8XC196NT SPECIFICATION UPDATE

Release Date: January, 1999

Order Number: 272865-004

Figure 1. ICC, IDLE versus Frequency

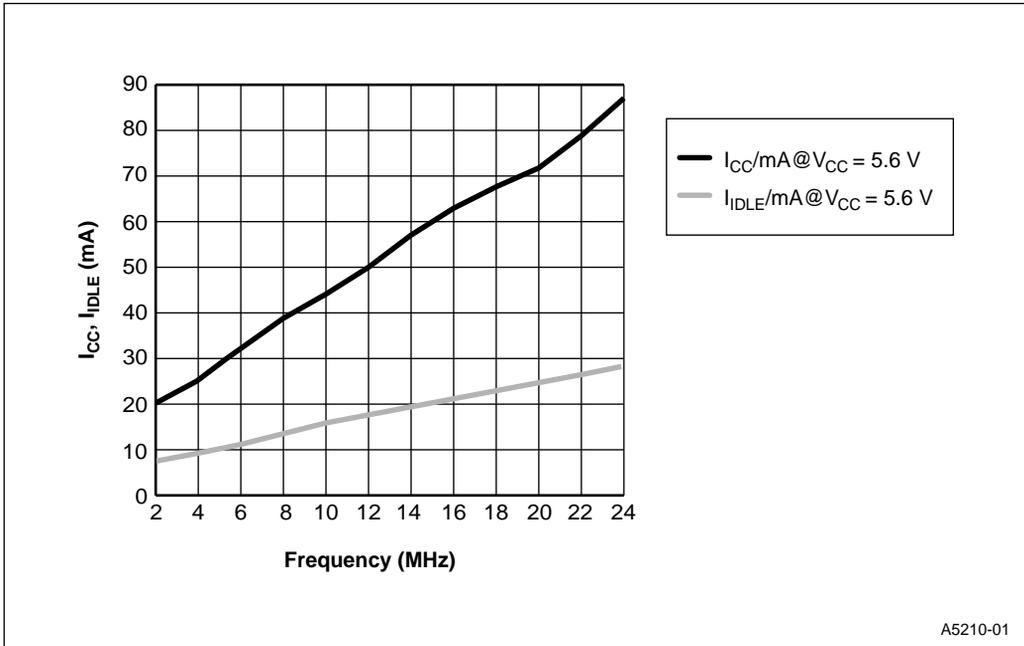
001. *Added ICC, IDLE versus Frequency graph; will be added to revision -005 of the datasheet.*

ITEM: The following graphic illustrating ICC and IDLE versus Frequency will be added to the next revision (-005) of the 8XC196NT CHMOS Microcontroller datasheet.
